# Document G701® – 2017

## Change Order

**PROJECT:** *(Name and address)*  
HCHS CTE Renovation  
2424 Zion Road  
Henderson, KY 42420

**CHANGE ORDER INFORMATION:**  
Change Order Number: 01  
Date: October 15, 2024

**HENDERSON COUNTY SCHOOLS**  
**CTE EXPANSION**  
**HENDERSON, KY**  
**CLASSROOM ADDITION SITE LAYOUT & GRADING**

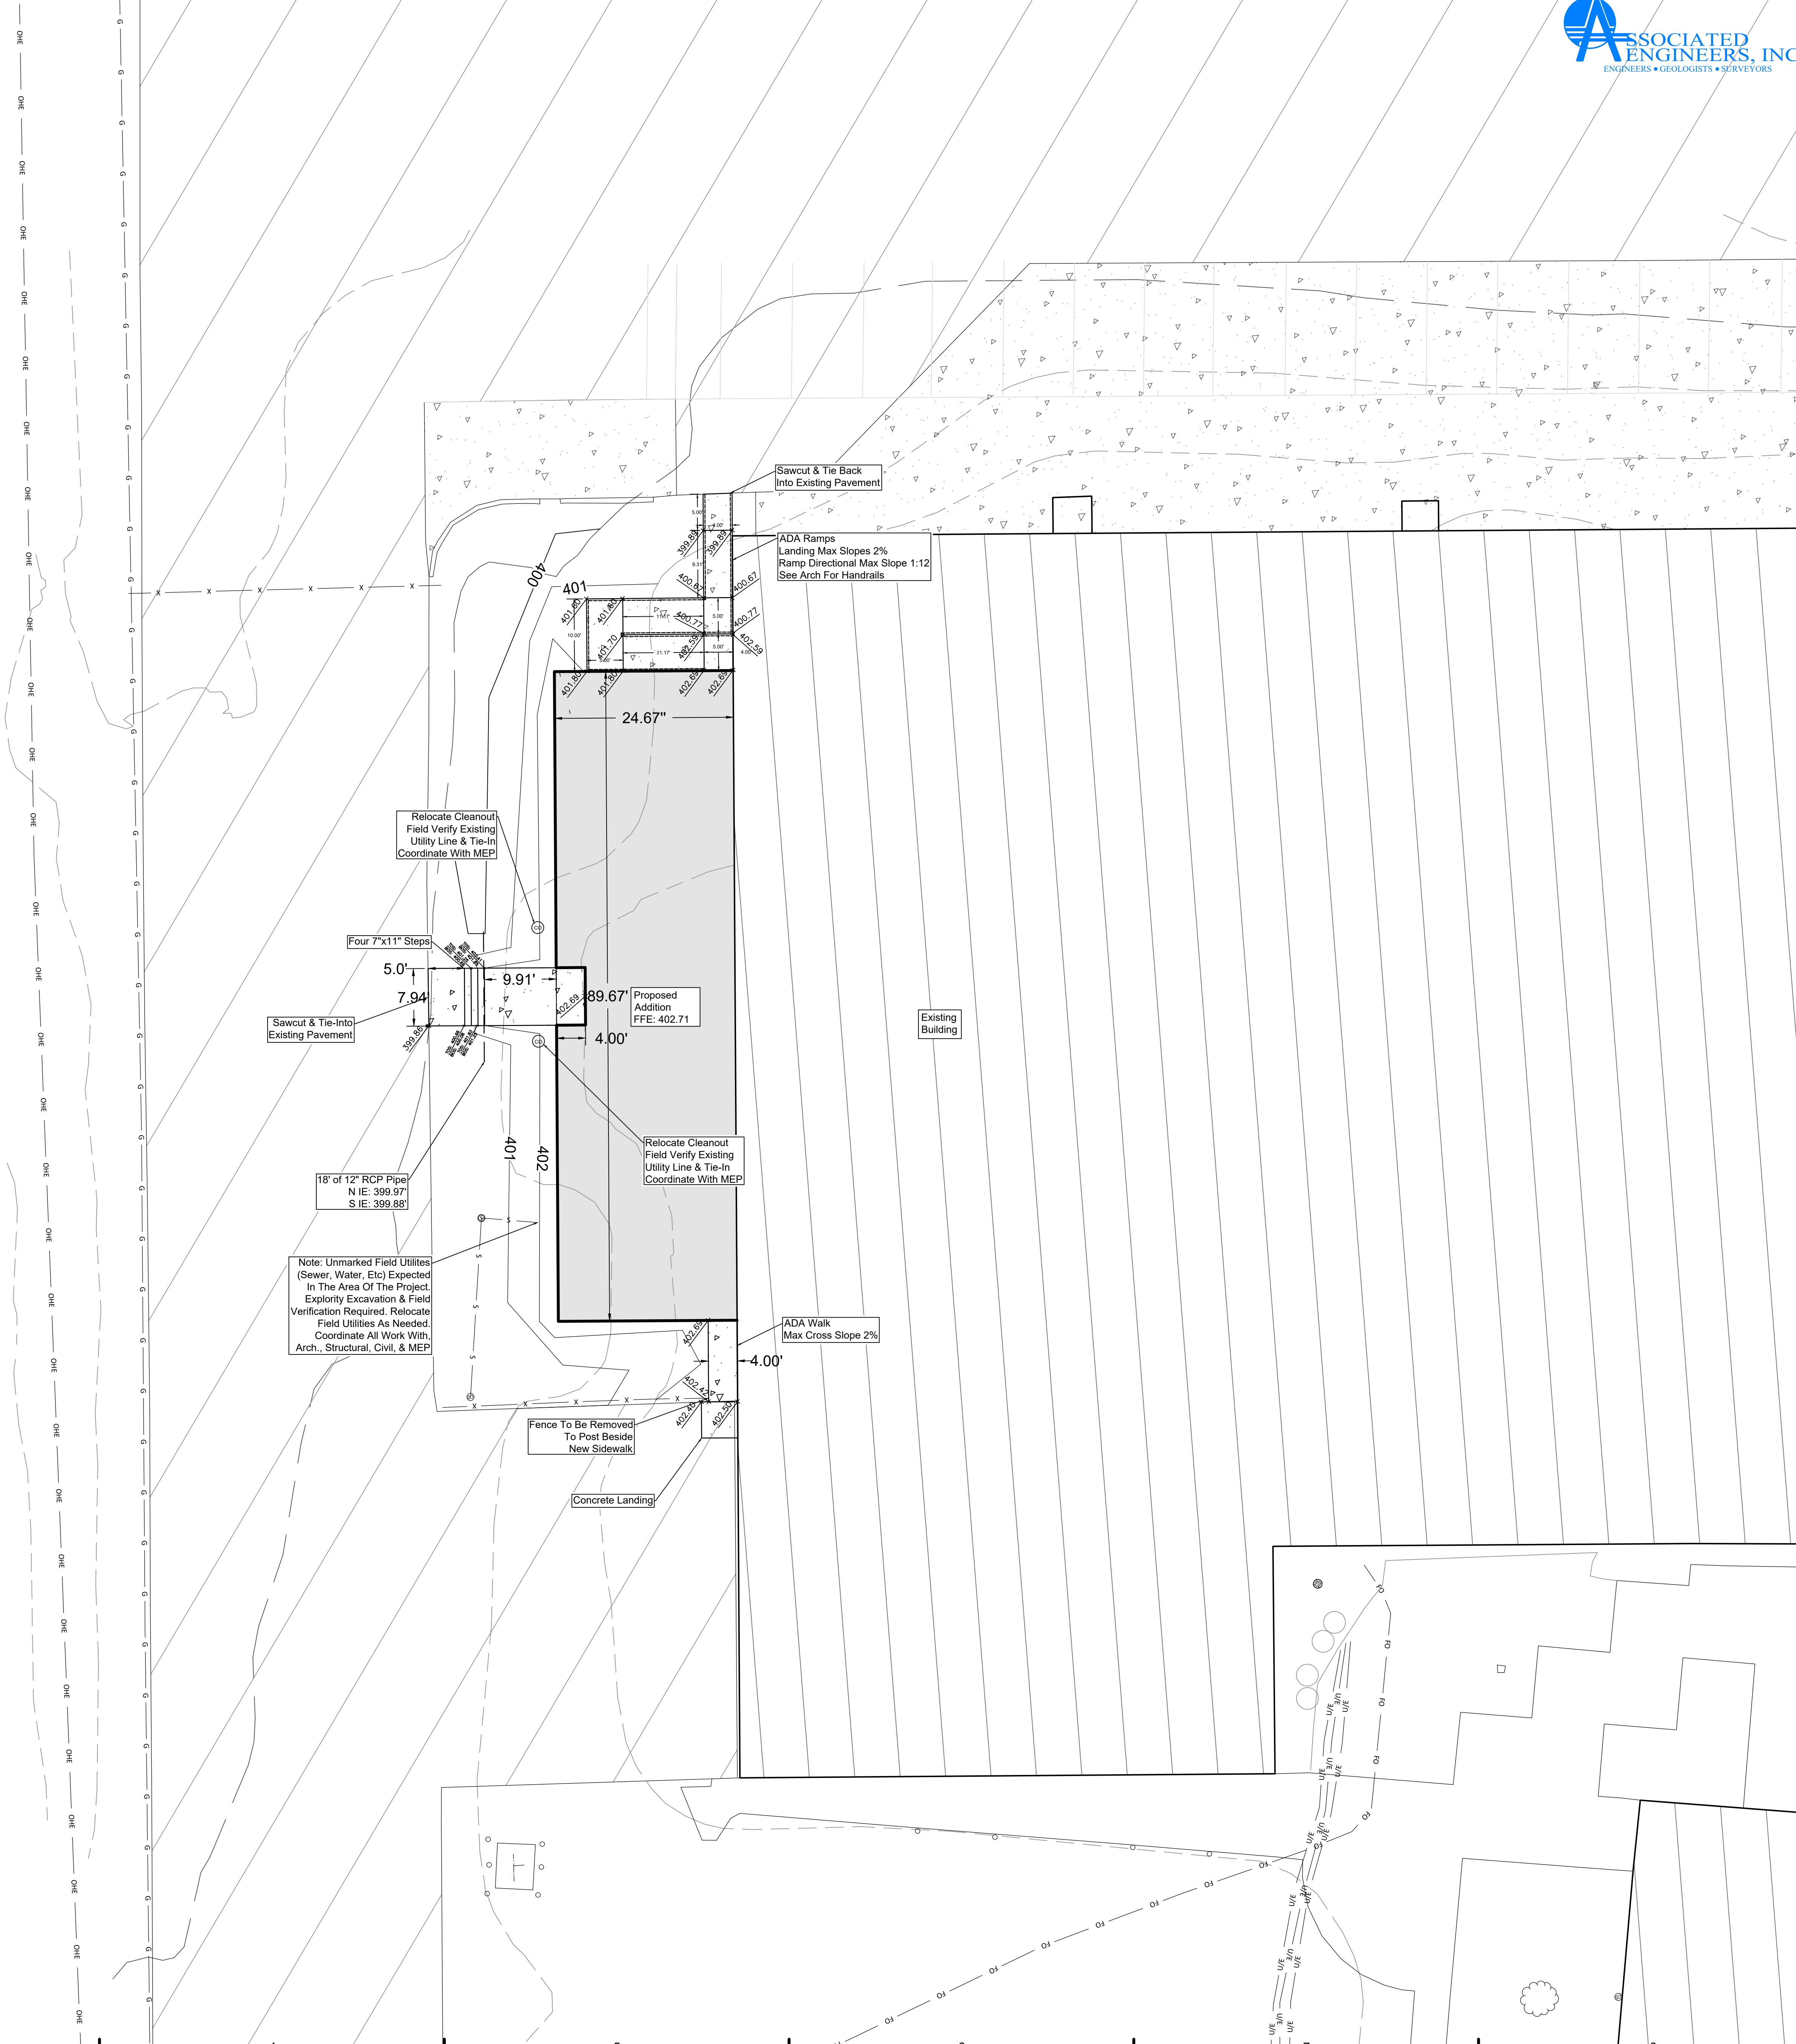
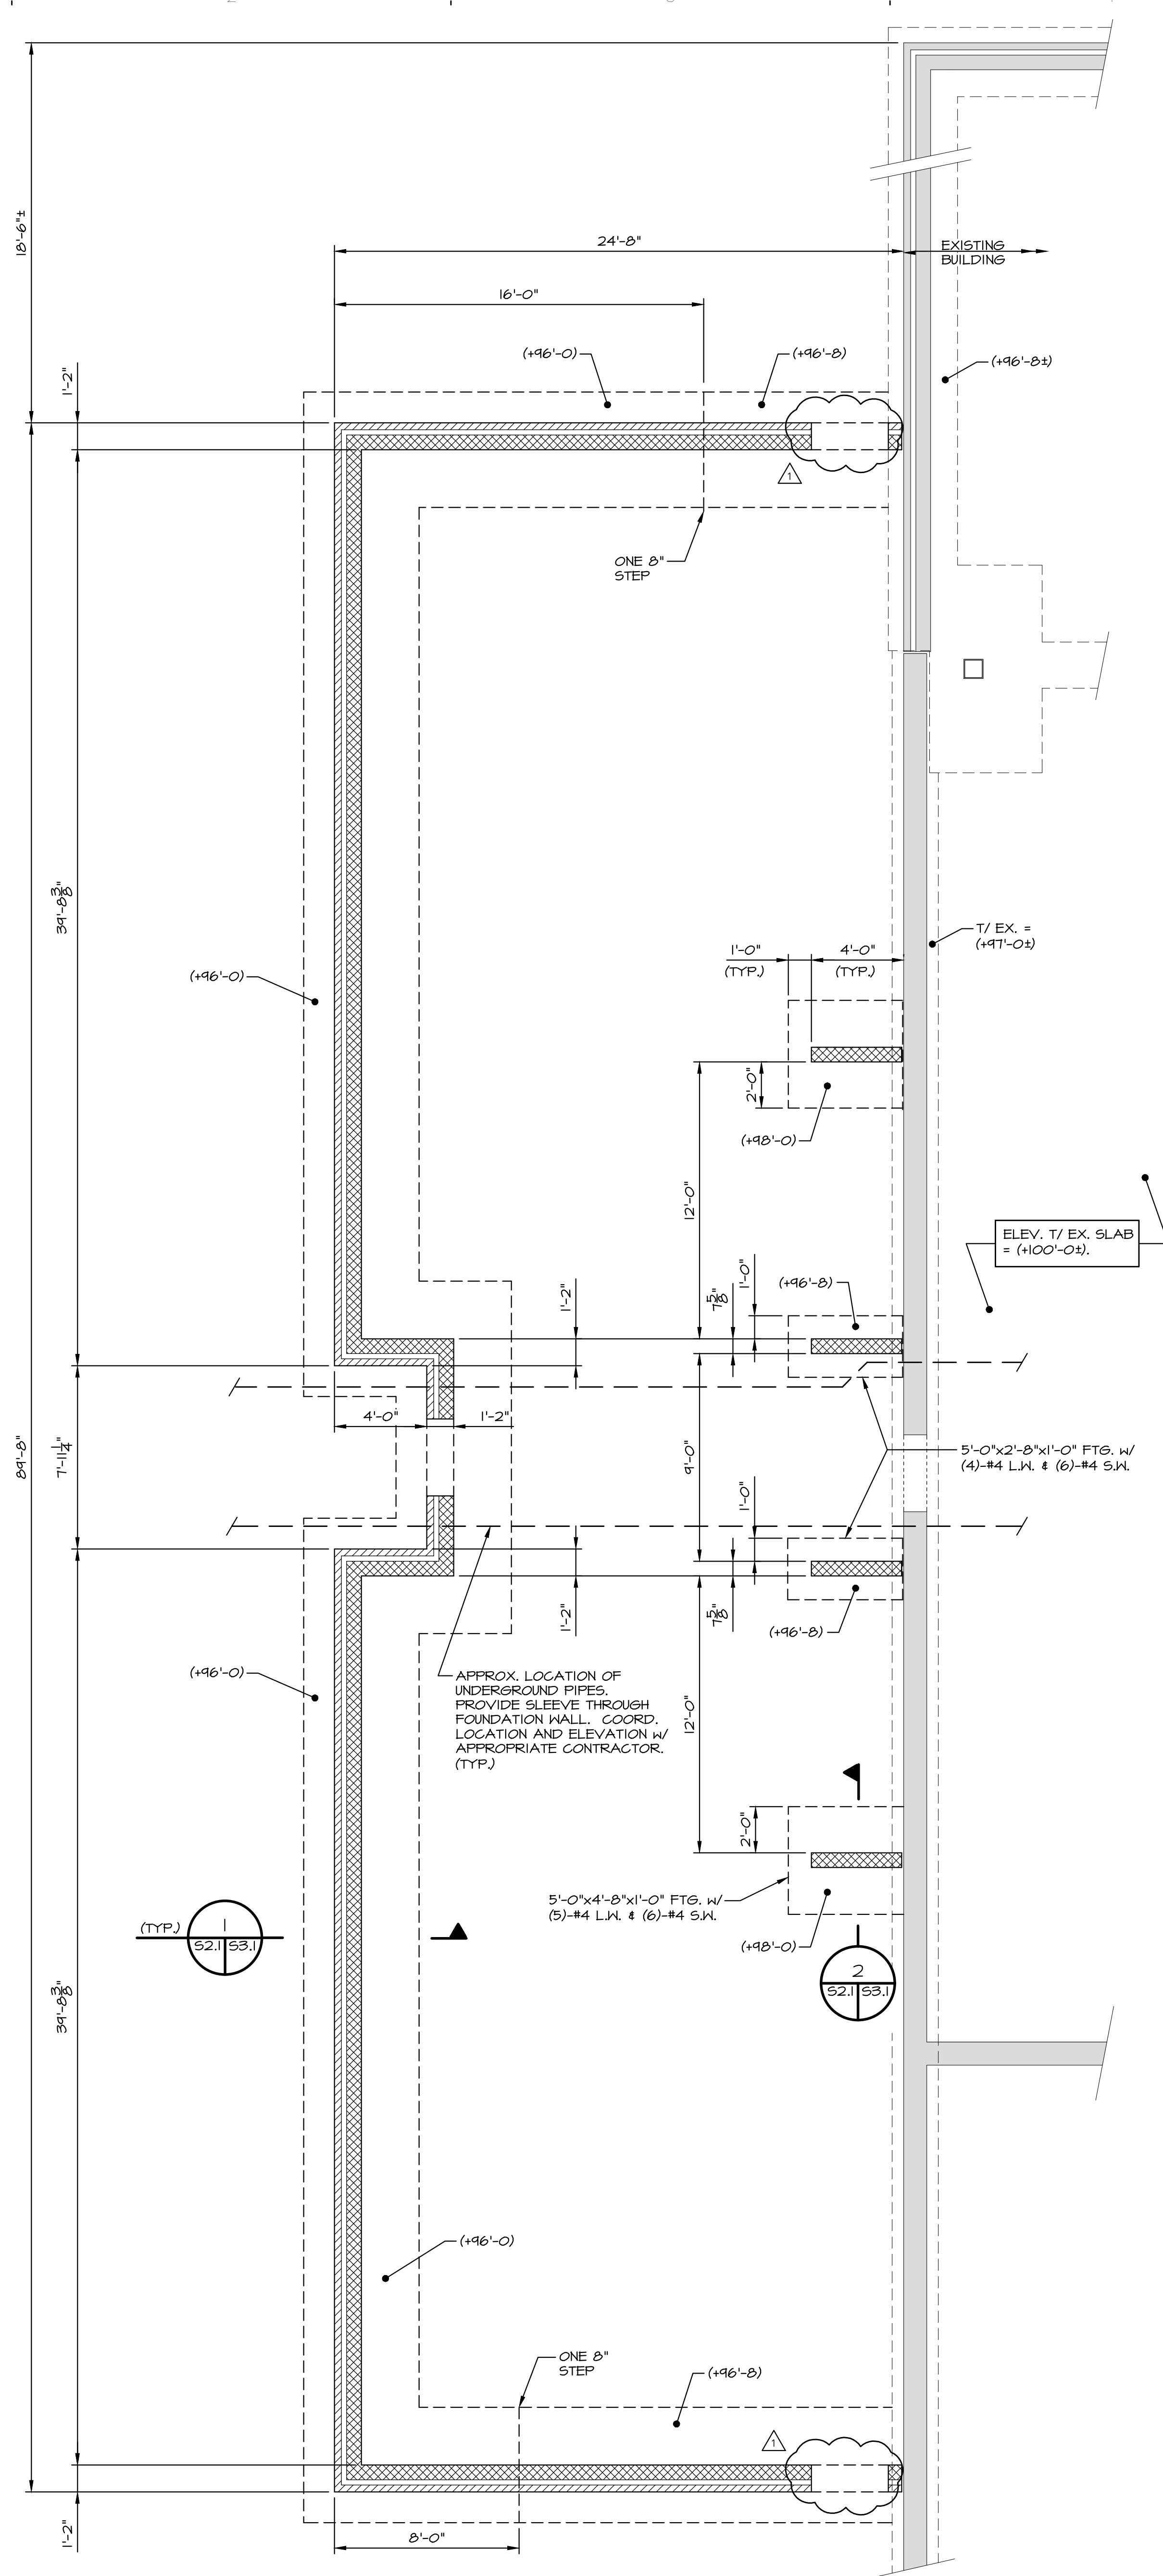
Provide a cost for the HBC required 2 means of exit for each of the new classroom additions.  
Includes:

- New Exit walk and landing pad
- New Exit Ramp & Guard Rails
- New Exterior Sconce Lighting at each classroom exterior door
- New Interior Exit signage at each classroom exterior door
- New Fire Alarm Pull at each classroom exterior door (interior)
- Revision of classroom exterior door panel type
- Revision of LVT to MCT (Mark C on Room Finish Legend)
